**UPDATE 1 to the
TECHNICAL DRAINAGE STUDY
for
Fort Apache-Sky Pointe Storage**

Job No. 21011

Re: Response to NDOT Comments for Fort Apache-Sky Pointe Storage
Reynolds Engineering Co. Job No. 21011

Cross Section for Section 1 - N 1/2 Sky Pointe Dr (Int 10-yr)

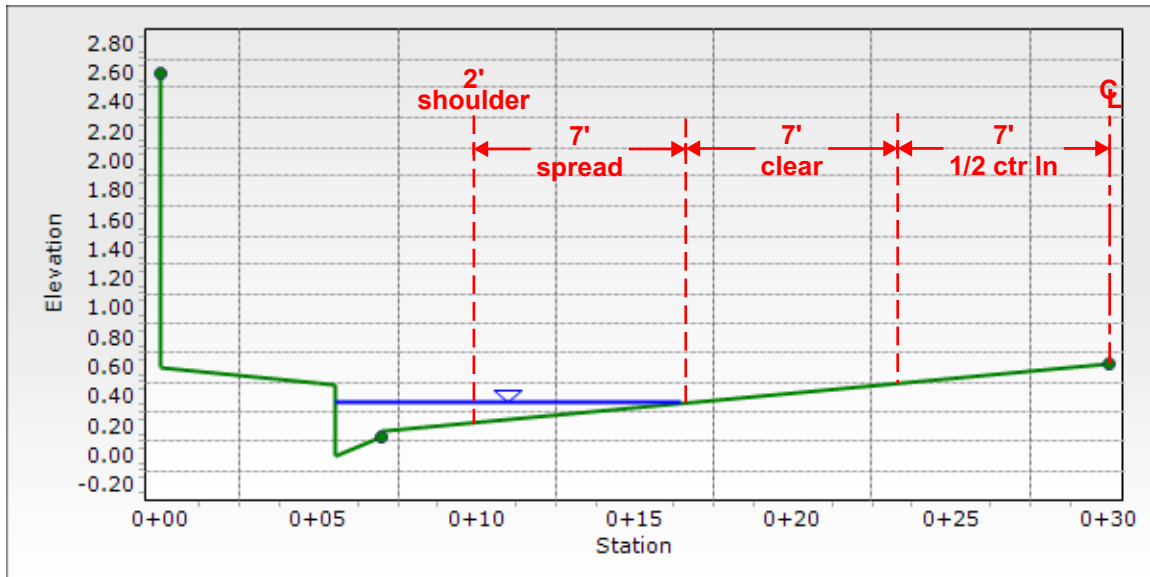
Comment 1: Please include additional drop inlets to contain spread violation on Sky Point Dr, and submit spread calculations.

Response 1: It is unreasonable to request this project install new storm drain and drop inlet in Sky Pointe Dr to remove 1 cfs from the roadway to meet the spread criterion. Instead, a detention basin behind solid grout CMU wall with a 12" x 8" opening has been added in the southwest of the site to detain a portion of runoff from on-site basin OND1. The design limits 10-year flow from OND1 into Sky Pointe Dr to 1 cfs. Peak 10-year flow in the roadway has therefore been reduced to 6 cfs. Spread in the 14-ft wide travel lane has been reduced to 7 ft, or 1/2 lane width as required.

The surface area of the inundation at incremental water surface elevations was found in AutoCAD and the values input in the SA card in HEC-1. The submerged orifice calculation for the outflow was prepared using FlowMaster. Note the calculation utilized an orifice height of 4", or 0.34 ft. to account for 50% clogging as required. A rating table shows the outflow of the detention basin at corresponding water surface elevations used for the SQ card in HEC-1. Velocity at the outflow during peak stage of 87.08 ft. exceeded 5 fps. The bottom of the detention basin is called out to be lined with 4" loose riprap and the swale within the NDOT right-of-way is called out to be lined with Class 300 riprap on the attached grading plans. The detention basin drains within the 6-hour design storm, which meets the Clark County Regional Flood Control District criterion it drain completely within 24 hours.
